ADDENDUM # 2

IFB #2929 Concrete Pad Addition for Recovered Materials Processing Facility

CONCRETE PAD ADDITION FOR RECOVERED MATERIALS PROCESSING FACILITY

CONCRETE PAD PLAN, SECTION, & GENERAL NOTES

S1.01

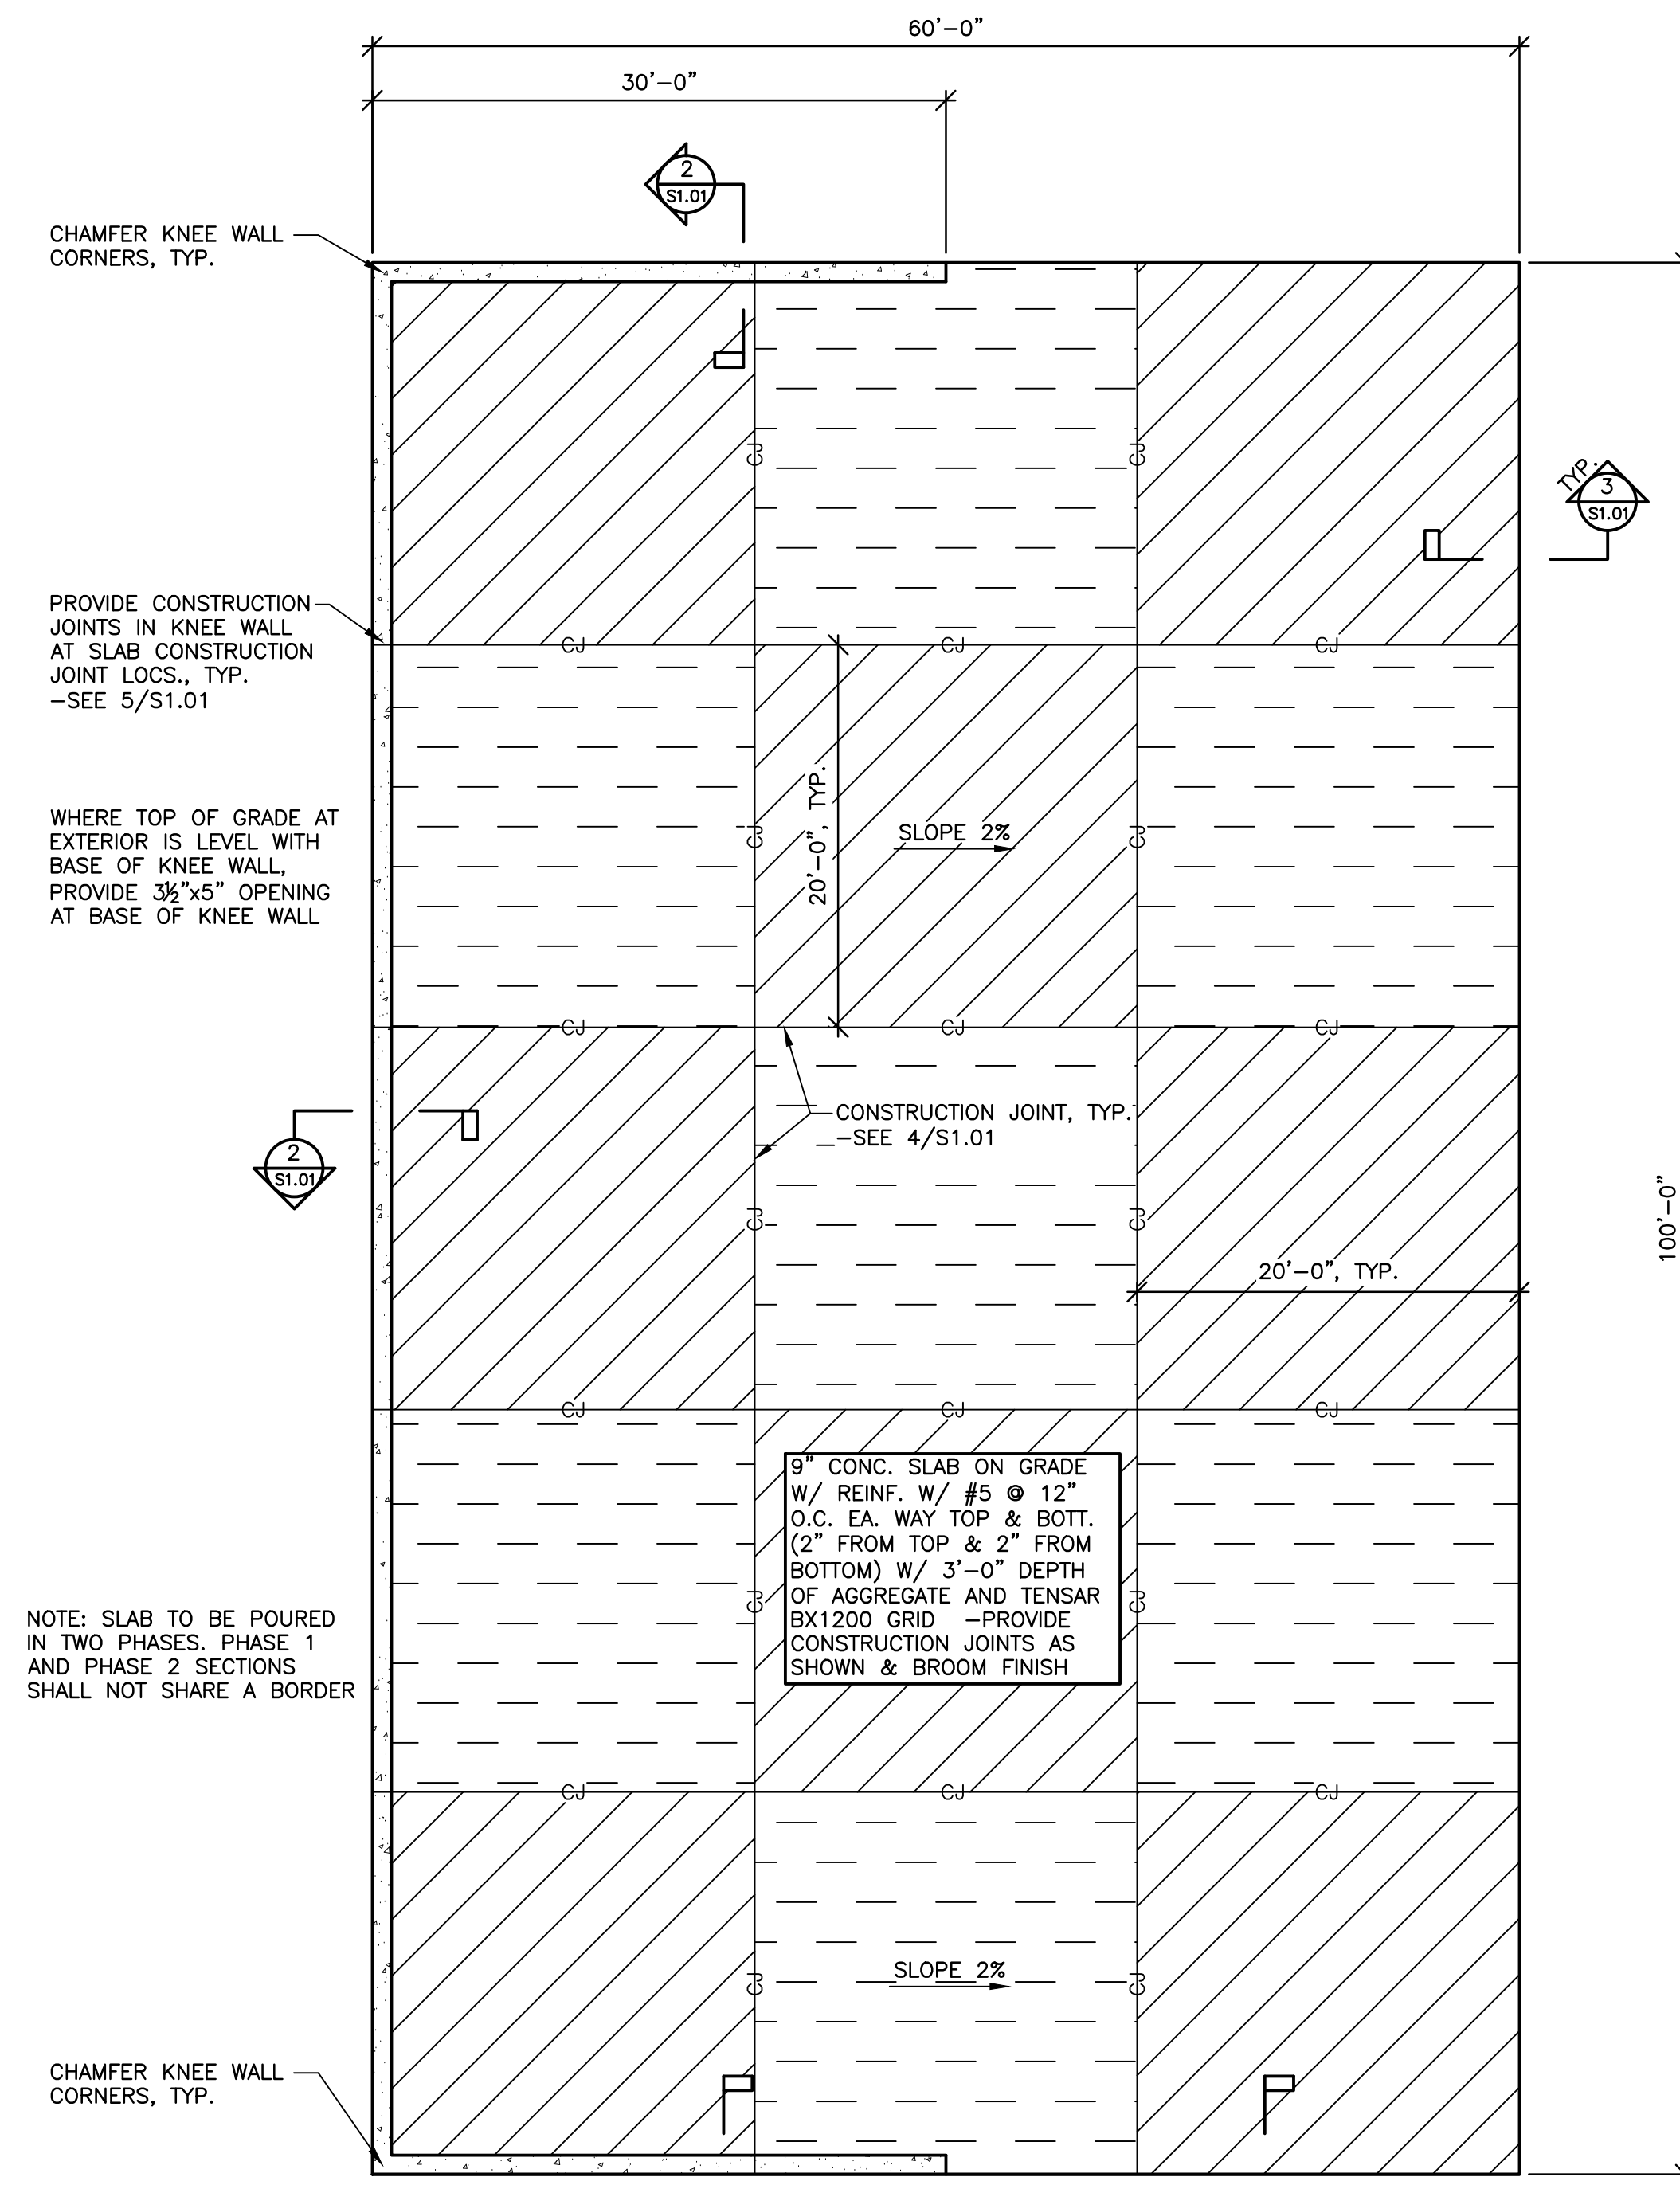
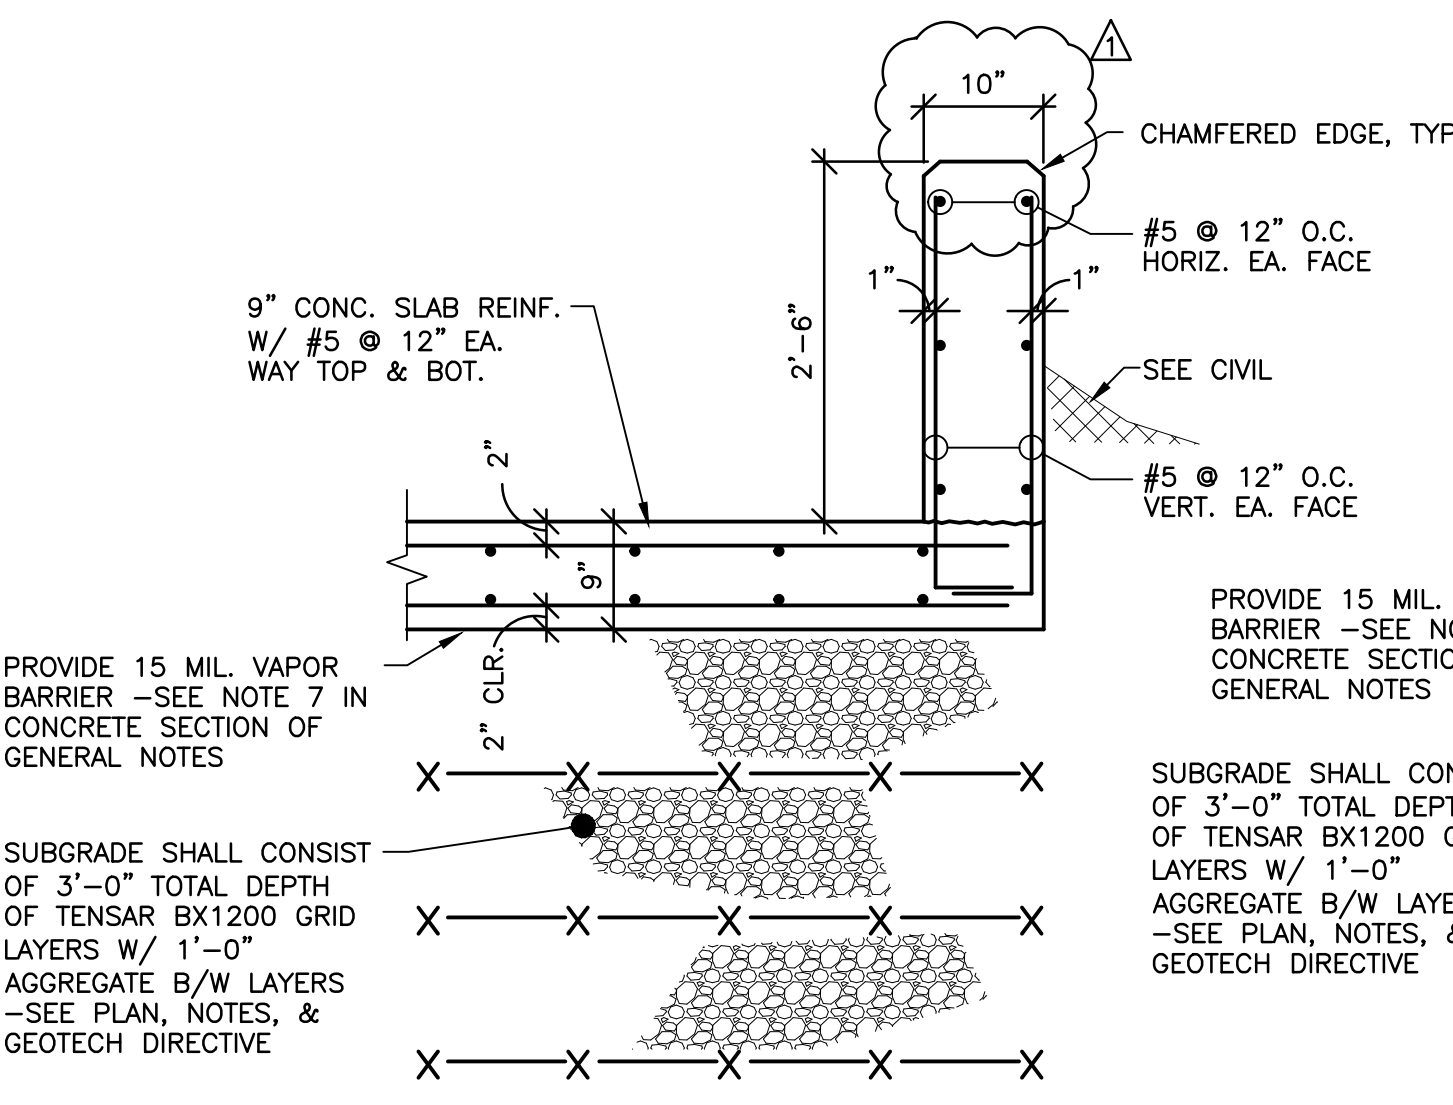
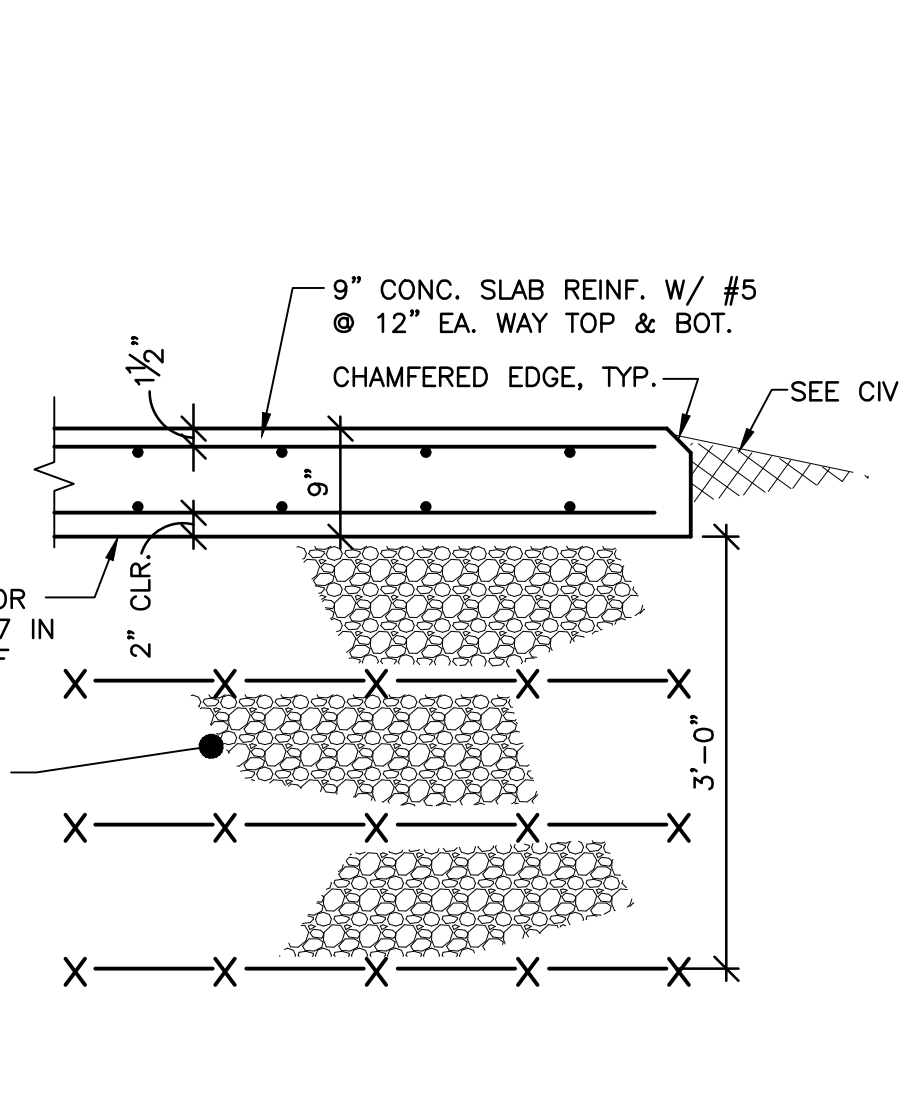
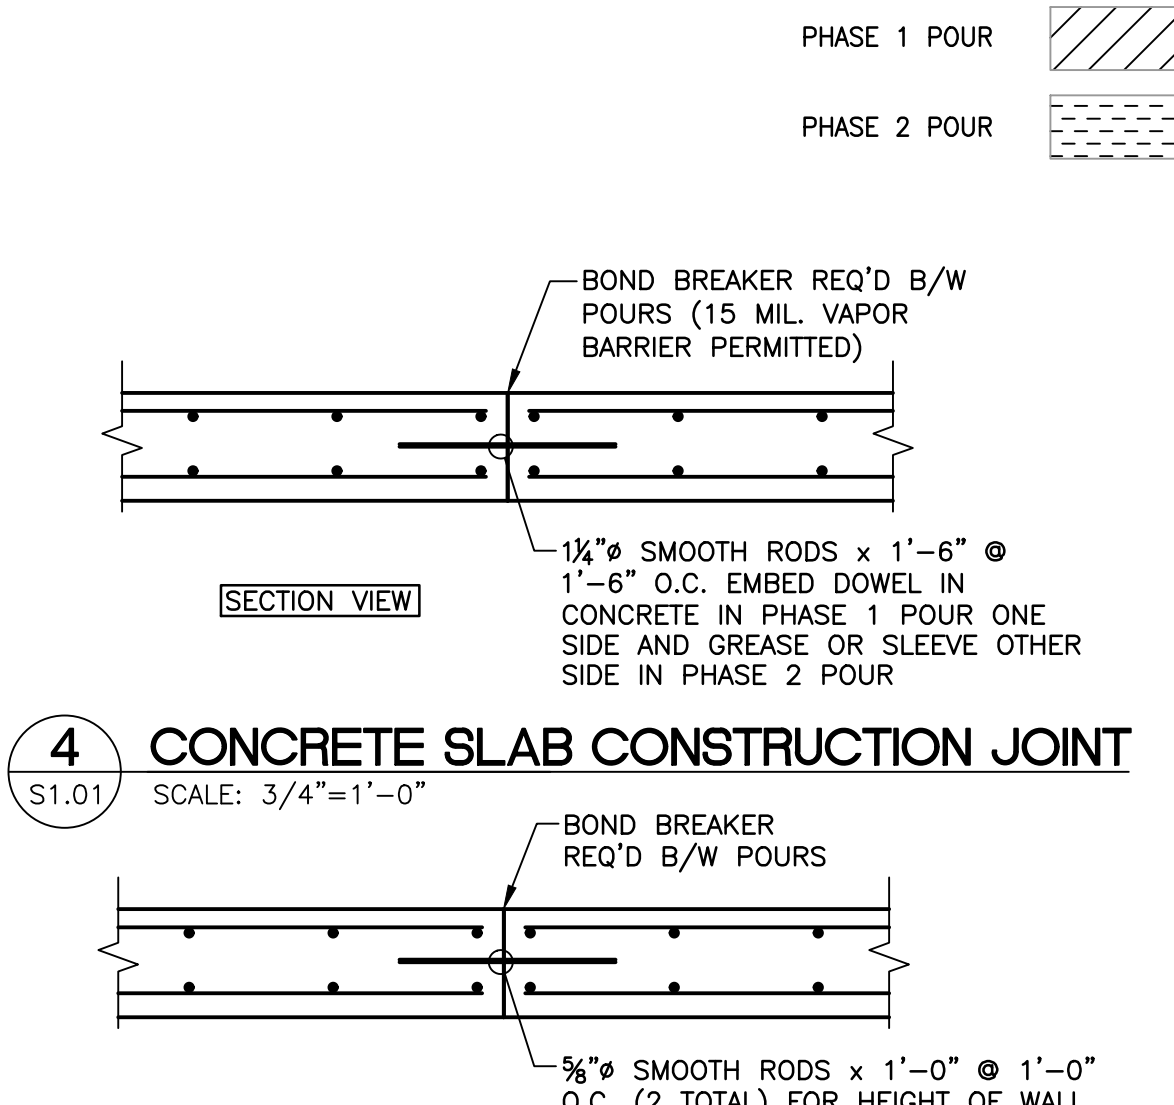
REVISIONS		
NO.	DATE	DESCRIPTION
1	06/13/24	DIM. CLARIFICATIONS
